PCN-20190711 TEC0850-03-* SPI Flash Change

Company	Trenz Electronic GmbH
PCN Number	PCN-20190711
Title	TEC0850-03-* SPI Flash Change
Subject	BOM change
Issue Date	2019-07-15

This change affects all Trenz Electronic TEC0850-03 SoMs: TEC0850-03-*

Locate Flash (U24 and U25) on top side of PCB:

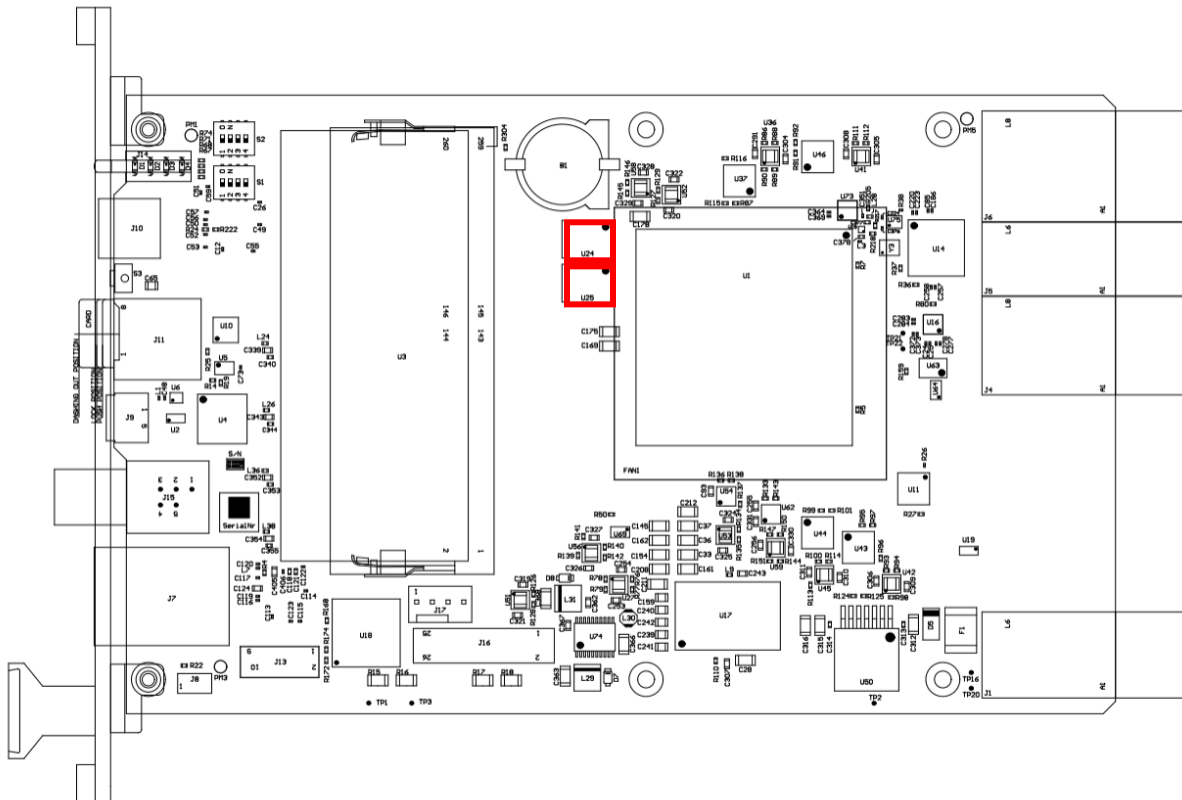
#1 Change SPI Flash from N25Q512A11G1240E to MT25QU512ABB8E12-0SIT

Reason: N25Q512A11G1240E became obsolete.

Impact: None. Both have same JEDEC ID BB20h and manufacturer ID 20h.

old	new
N25Q512A11G1240E	MT25QU512ABB8E12-0SIT
